COMMENT RESPONSE DOCUMENT

EASA PAD No. 17-073

[Published on 13 June 2017 and officially closed for comments on 11 July 2017]

Figure 1

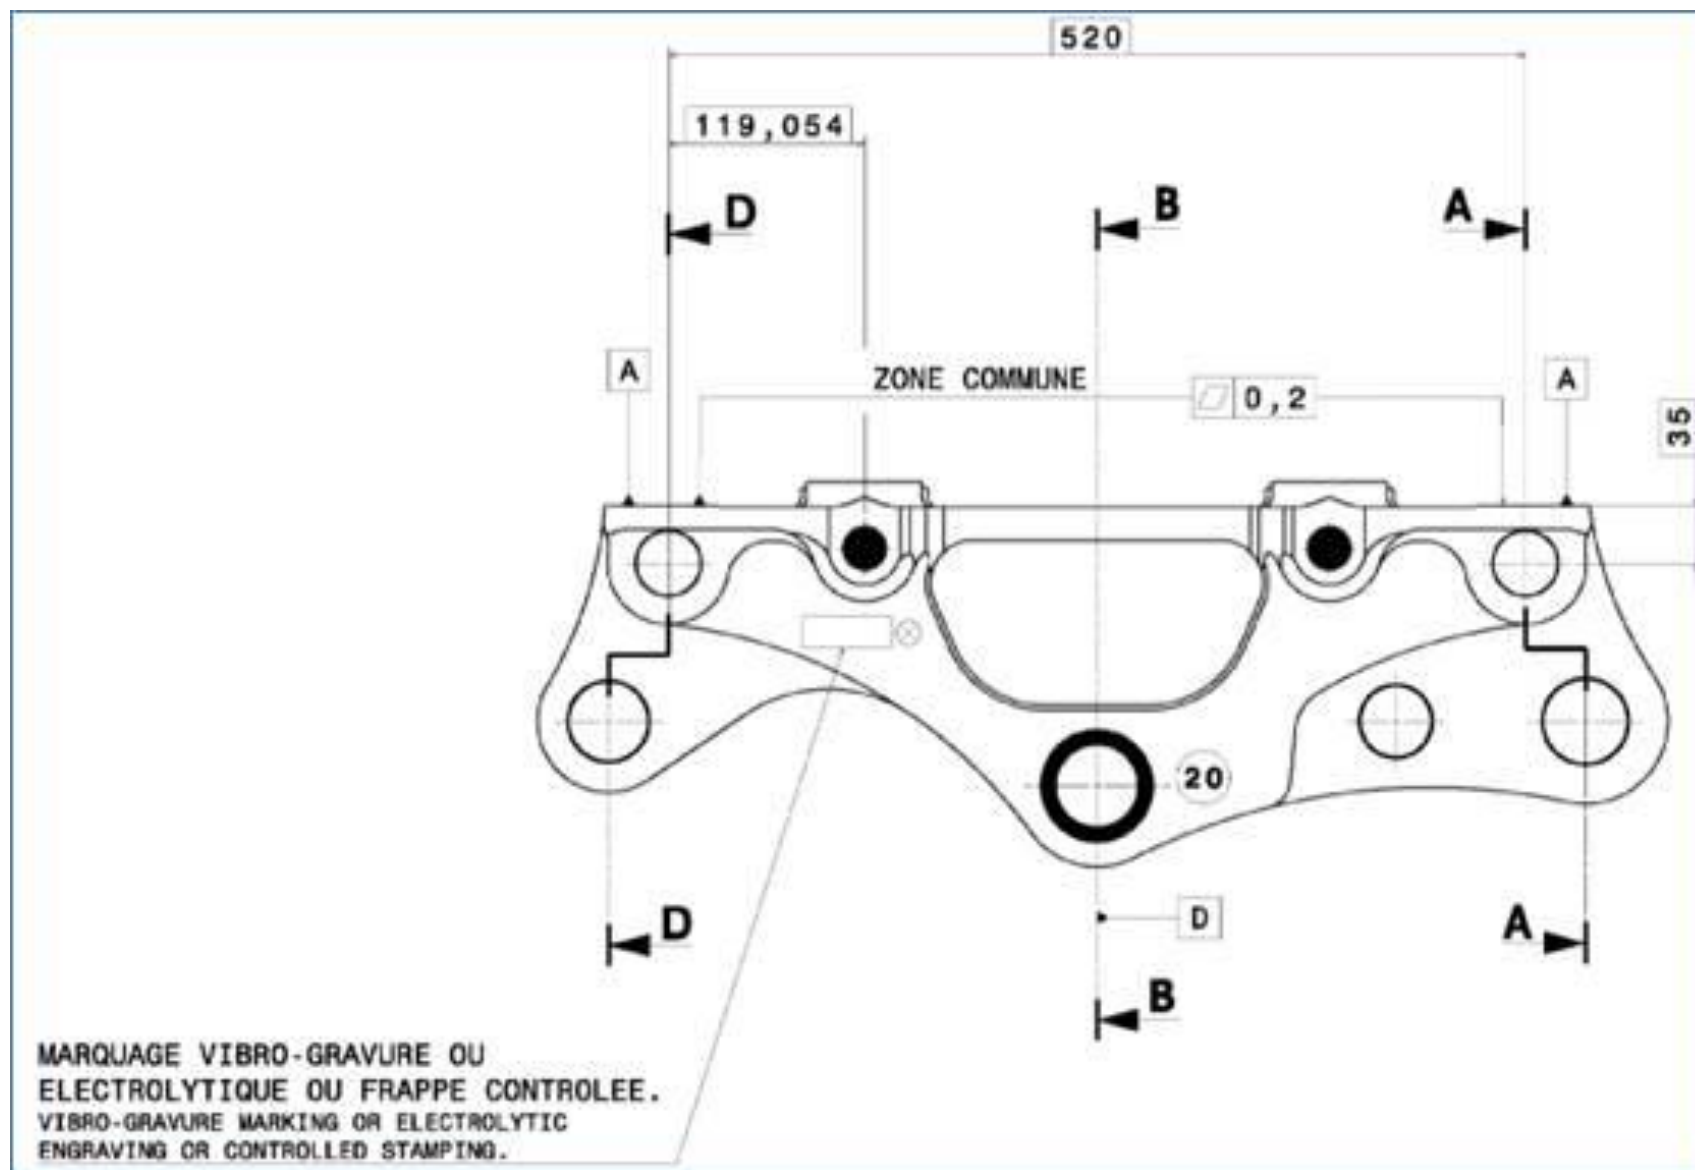
1. P/N L7121076120000 is not listed in the Qantas A380 AIPC.
2. The Qantas Rear engine mount serial numbers are all in the range SE10013 to SE10578. This serial number format is very different to that specified in the Airbus SB.

3. The SB is not applicable to mounts post SE465. Should this be written as SE00465, or even SE100465? Are the Qantas mounts SE10013-100578 considered after SE00465?

2. *Comment noted: The serial numbers with format SEXXXXX are provided for the rear mount assembly; in the SB we ask to check the serial number provided for the simple part L71210761200 in the front of the part, see Figure below for marking area. Basically the S/N number is usually provided in the same area, as the P/N L71210761200 see Figure 1.*
The serial number provided for the rear mount assembly is located on the side of the part, see Figure 2 below, and this serial number is linked to assembly number given in answer to question 1:
We have amended the revised PAD accordingly.
